THE ENTRANCE PENINSULA

06 April, 2011

Subject: **SUBMISSION ON TUGGERAH LAKES FLOODPLAIN
RISK MANAGEMENT STUDY.**

2004 Caterpillar 615C II

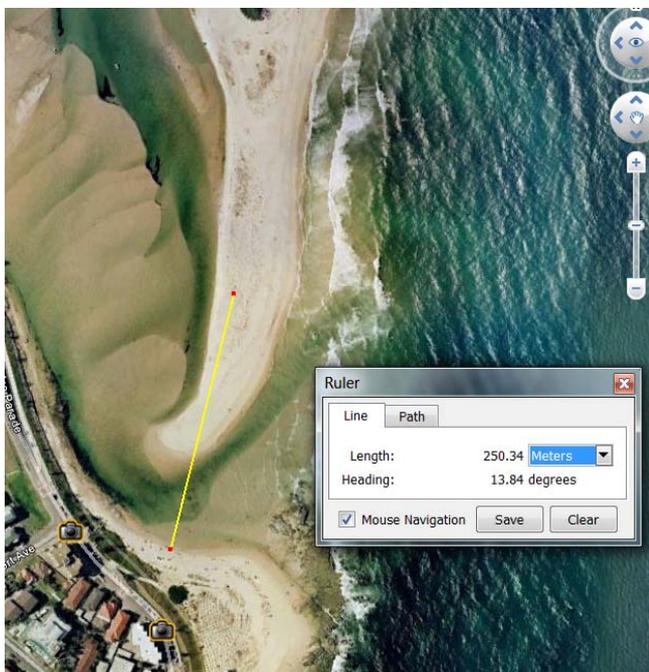
TEPCP requests that Council seriously considers- that by permanently maintaining a modified berm level 0.1m above the normal level of the lake to provide a 250m wide sand bar that is soon over topped in time of flooding as a good and achievable compromise to trying to open the channel itself.

- Adequate warning time is not an issues.
- A self elevating scrapper could be purchased by Council to remove the sand and spread it on North Entrance Beach at a cost less than one years dredging.
- The rate of rise of Tuggerah Lake: Above (say) 1.0 m AHD where the equipment would become bogged is not an issue.
- It is a safe option. The equipment and labour would work in a fine and calm weather, not in the harsh environment (rain, wind, ocean waves, rising water level, possibly darkness). that trying to open the channel in time of flood would involve.
- There is a very low risk to life and loss of equipment.

- It is a better option than channel dredging because it would be more effective in reducing flood levels.
- It is a more cost effective option to dredging than spending \$400,000.00 per year on dredging
